# Turbo HD DVR V3.4.89build 180906 Release Notes (2018-09-10)

Firmware Version:	V3.4.89build 180906
	SDK Version::	V5.3.6.30_build20180816
	Onvif:	V2.2
Firmware  Basic  Information	Player:	4.81mini
	Player library:	7.3.0.0
	Web version:	V4.0.1build180903 Plugin
		Version V3.0.6.27
	Client version :	Baseline V2.6.11.5
		build20180904
		hilook V2.7.1.50
		build20180824

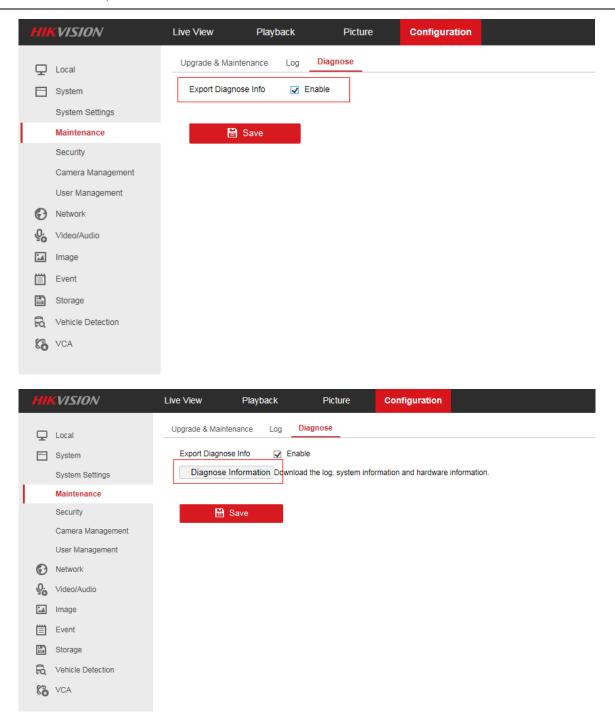
- i. Support disable analog channels to add more IP cameras;
- ii. Collect device RS-232 serial port print information is supported by saving the debug.cfg file to USB drive, then insert the USB drive to DVR. Every time the device reboots, the USB could collect the print information automatically;
- iii. Newly support to export the diagnostic information of device via web remotely and the exported information is saved in the form of a file.
  - Configurations of local GUI and web page are as below:

- 1. Enable Export Diagnose Info firstly;
- 2. Click the Diagnose Information button to save the diagnose info;
- 3. The diagnose information records the running status of the device, which is very useful to solve the customer issue. The diagnose information is encrypted (If you open it directly, it will show some random code) and only the R&D have the authority to decrypt.
- iv. Newly support to recover device password via reserved email. Input a reserved email address while activating the device, when the device password is forgotten, you can click Forget Password ->
